Project Name: Pinehaven Stream Improvements
Project Number: IZ089000

Subject: Response to section 92 requests for further information - submissions

Subject	Response to Jan 23 2020 Section 92 Request - Mapping 8 December 2019 flood event	Project Name	Pinehaven Stream Improvements Project
		Project No.	IZ089000
Author	Damian Debski		
Date	February 26, 2020

Between Birch Grove and Pinehaven Road:

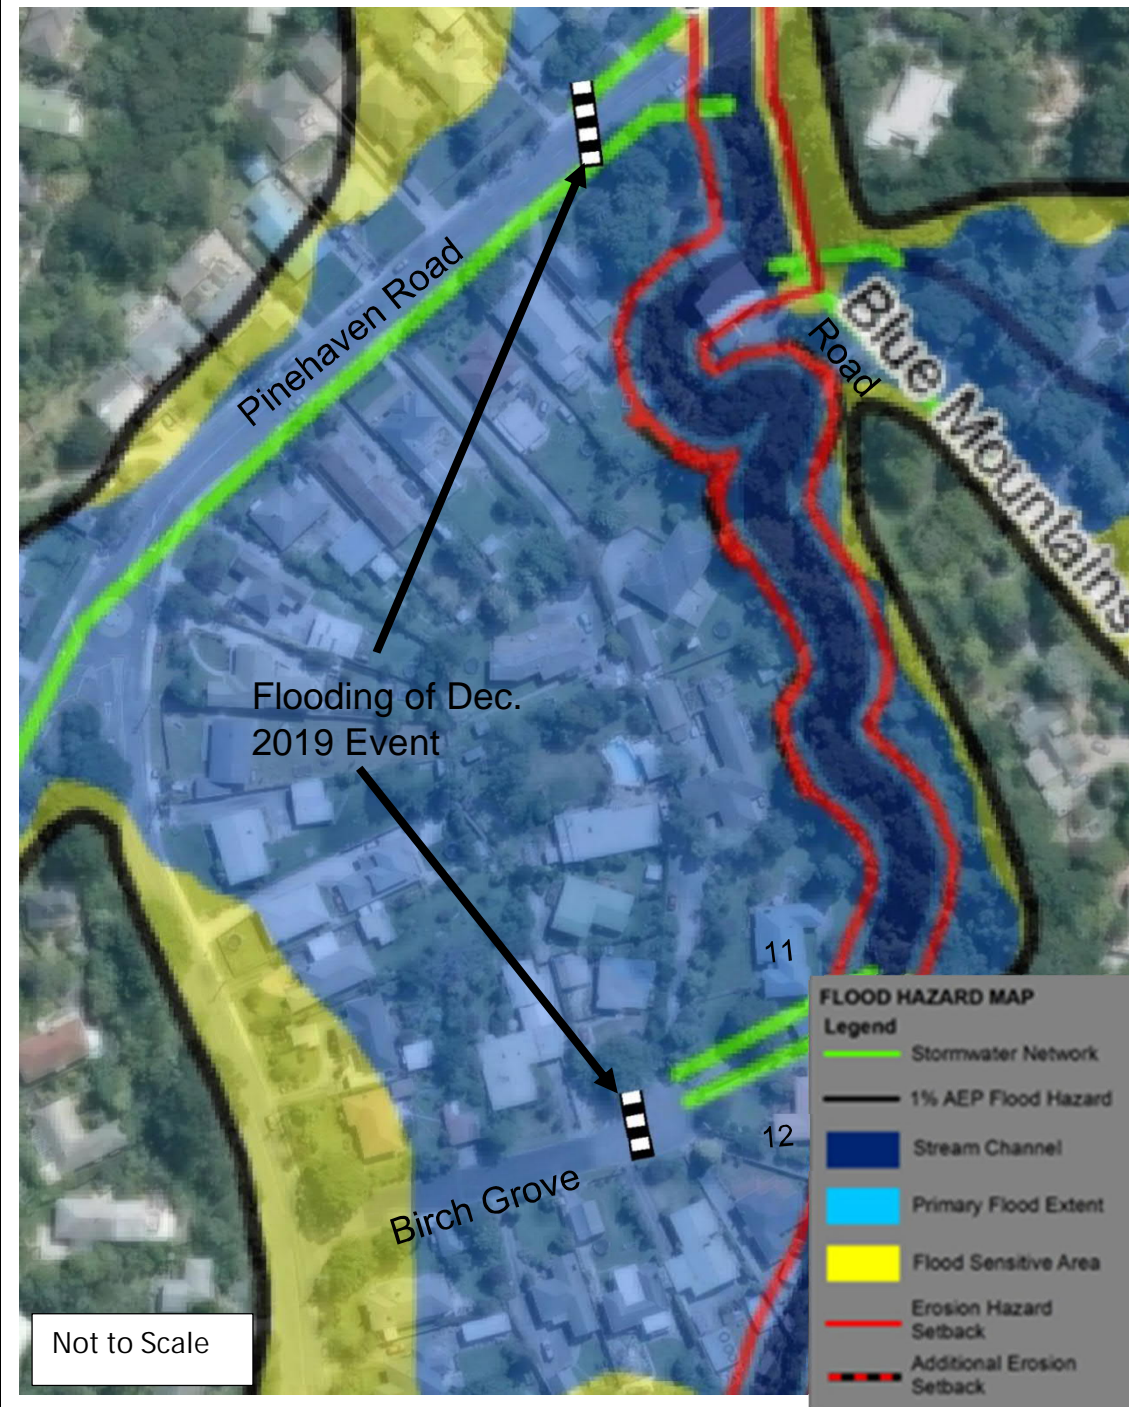
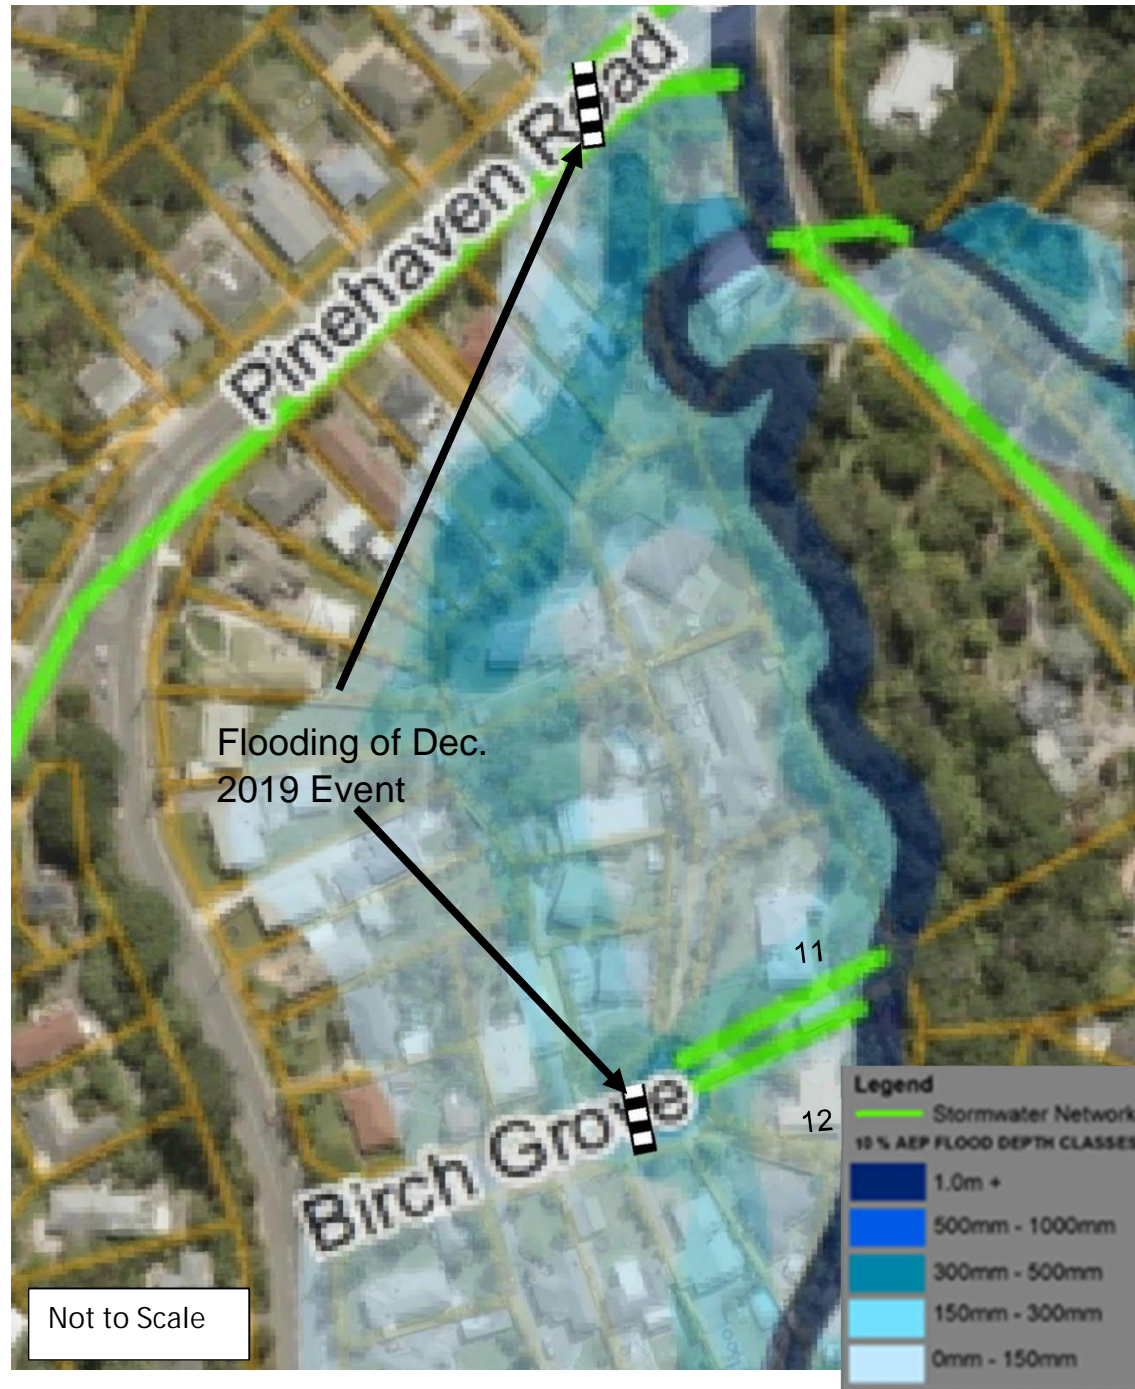
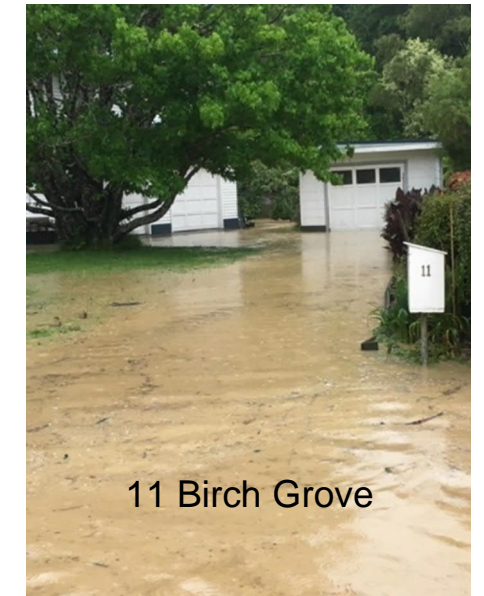
- Birch Grove to Pinehaven Road:

The flooding photographed at 11 and 12 Birch Grove is predicted in both the 10-year and 100-year model flood extent. The photographs do not show how far along Birch Grove the flooding extended. Debris photographed at Pinehaven Road on the true left bank of the Stream is approximately at the 10-year model flood extent.

In this section of the Stream the observations indicate flooding was at least as extensive as the model 10-year flood extent.

Between 26 and 36 Blue Mountains Road:

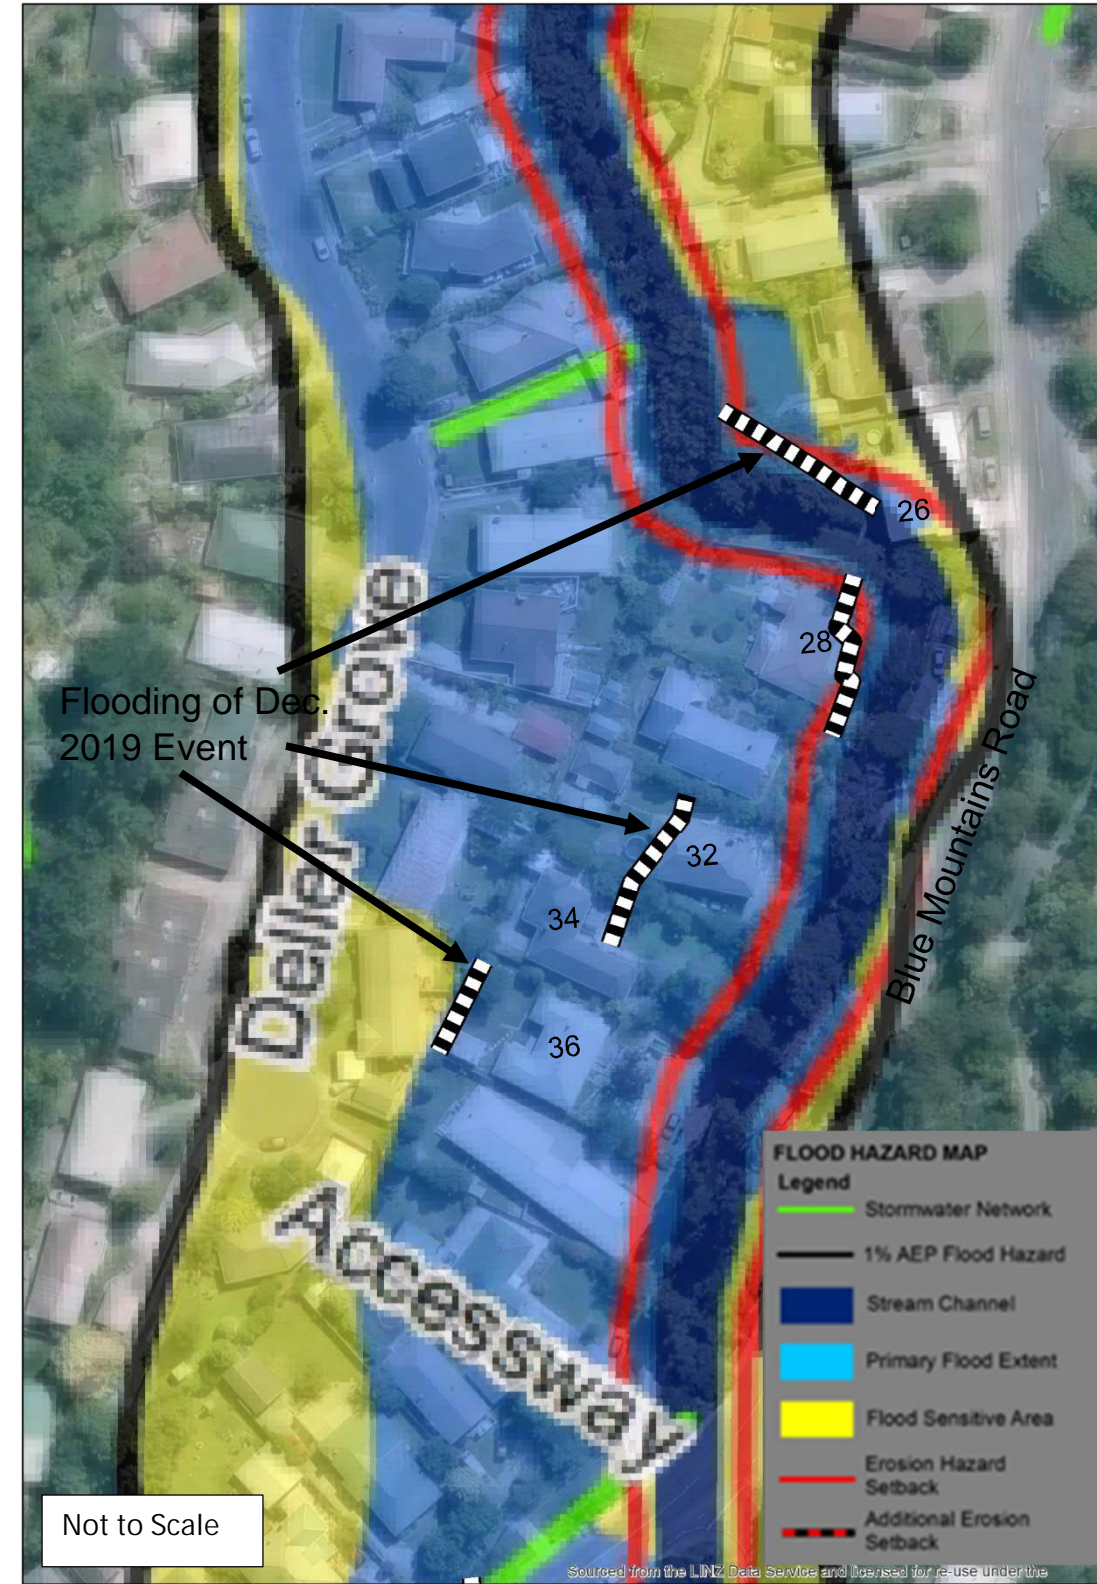
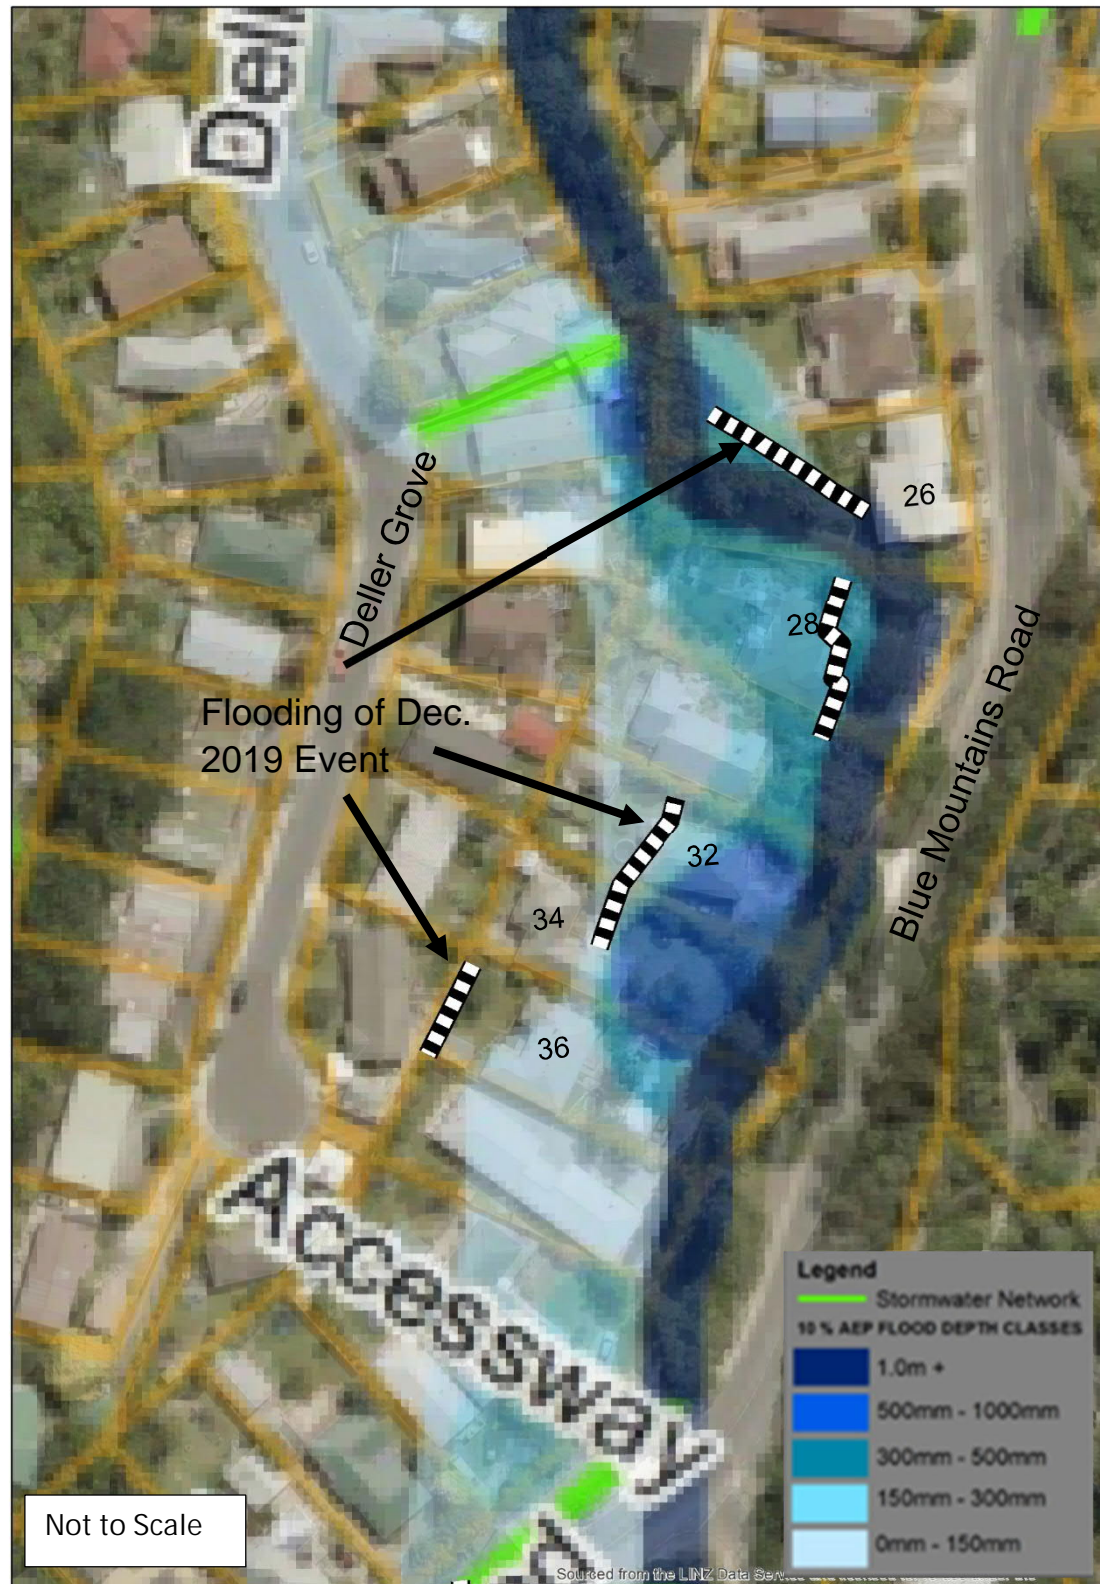
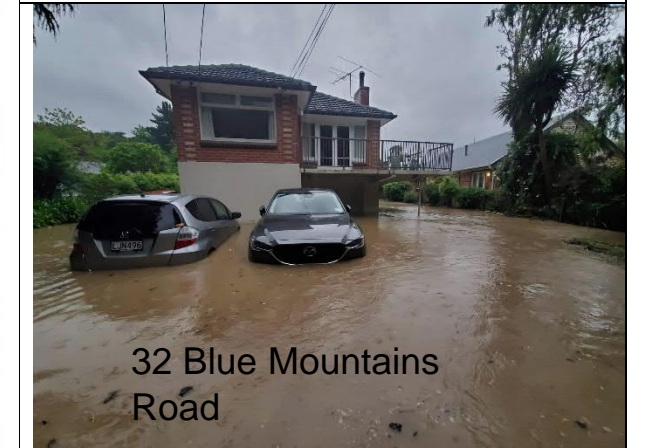
- Between 26 and 36 Blue Mountains Road:

The flooding and debris recorded at No. 36 Blue Mountains Road appears to be consistent with the model 100-year flood extent. At Nos. 26, 32 and 34 Blue Mountains Road the records appear to be consistent with the model 10-year flood extent. At No. 28 the extent of flooding to the rear of the property cannot be established from the photographs – evidence of flooding to the front of the property is within the model 10-year and 100-year flood extent.

In this section of the Stream the observations suggest the flooding lies between the model 10-year and 100-year flood extent.

Between Sunbrae Drive and Willow Park:

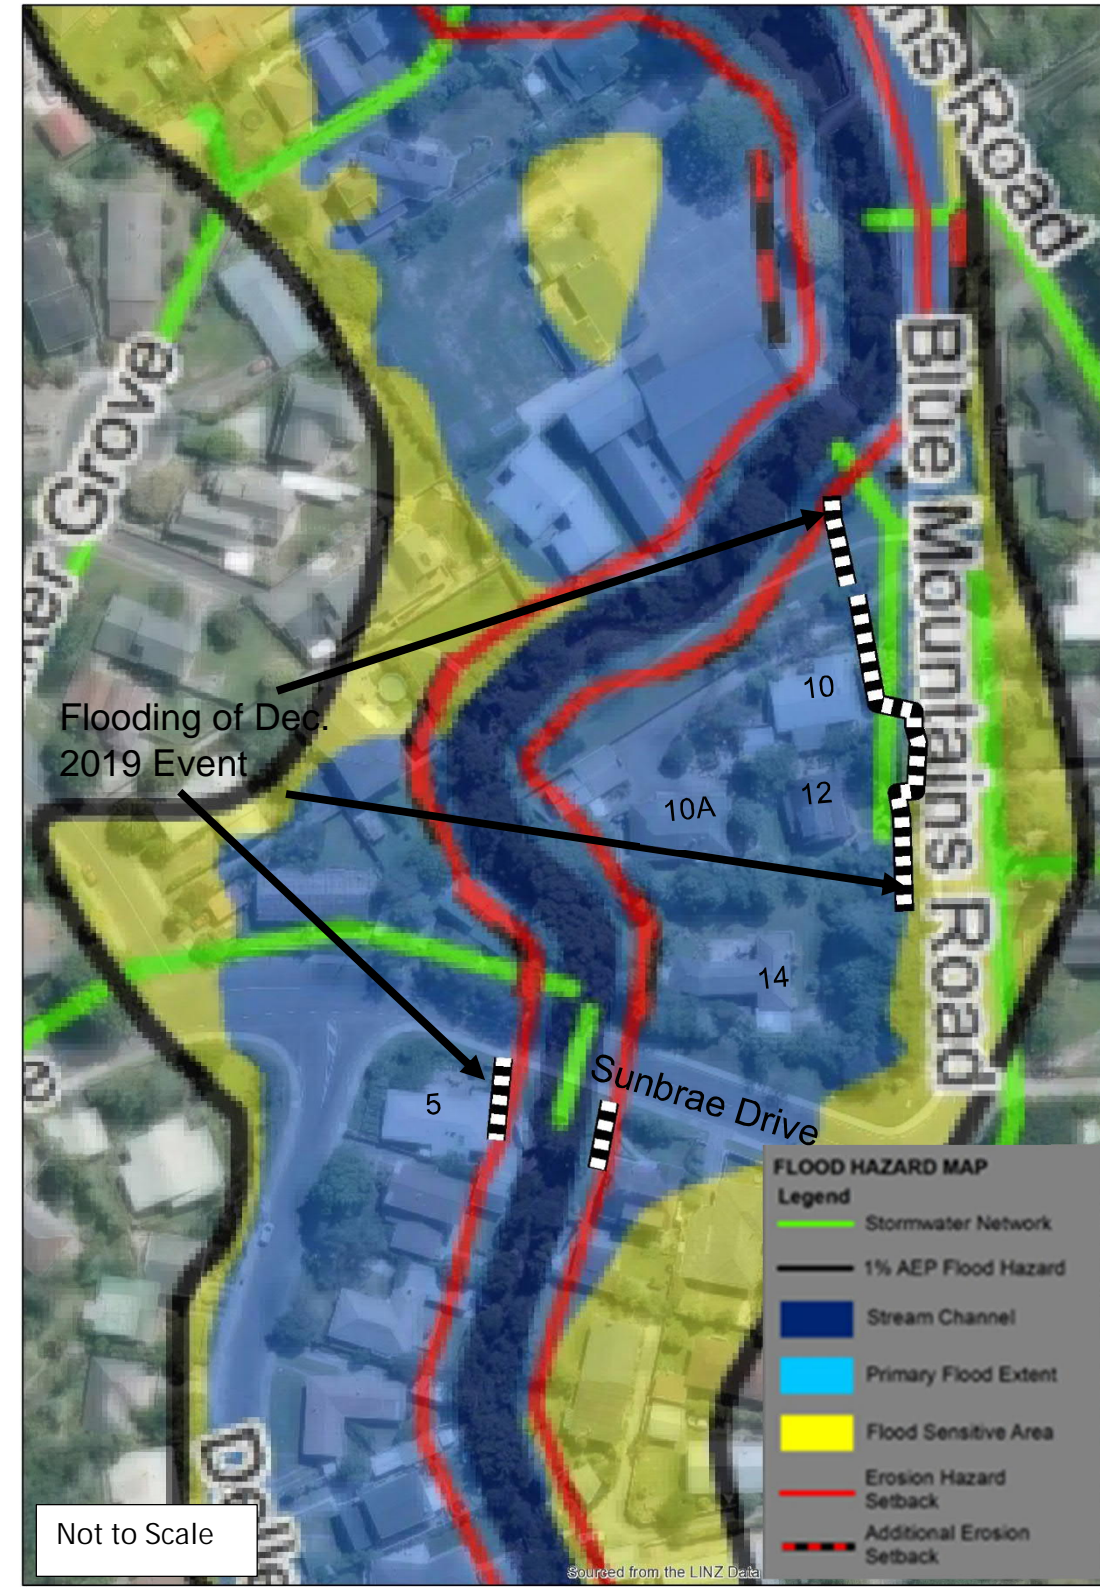
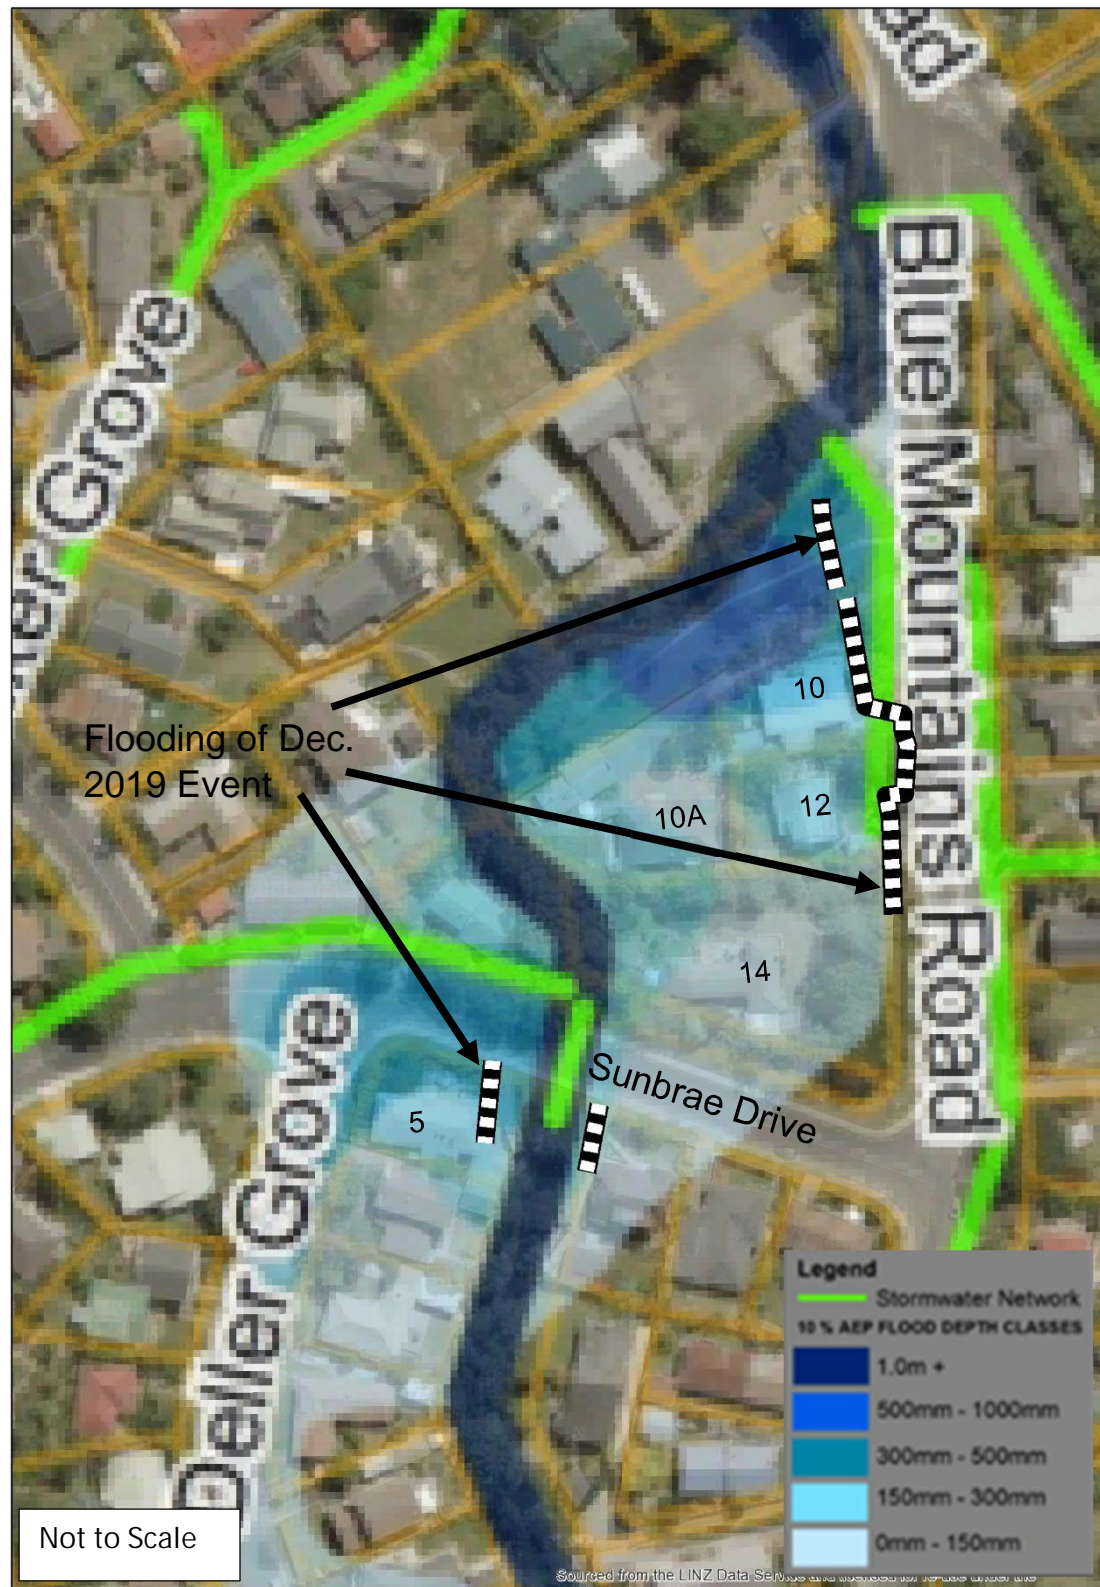
- Between Sunbrae Drive and Willow Park:

Debris recorded on the south side of Sunbrae Drive appears to be consistent with the model 10-year results for deeper flooding. However, the extent of flooding along the road is not clear from the photographs. Recorded flooding at Nos. 10, 12 and 14 Blue Mountains Road appears similar to both the model 10-year and model 100-year flood extents. Flooding is contained at this location by the rise in ground level along Blue Mountains Road. In Willow Park, the debris recorded appears to be consistent with the model 10-year extent.

In this section of the Stream the observations suggest the flooding lies between the model 10-year and 100-year flood extent.
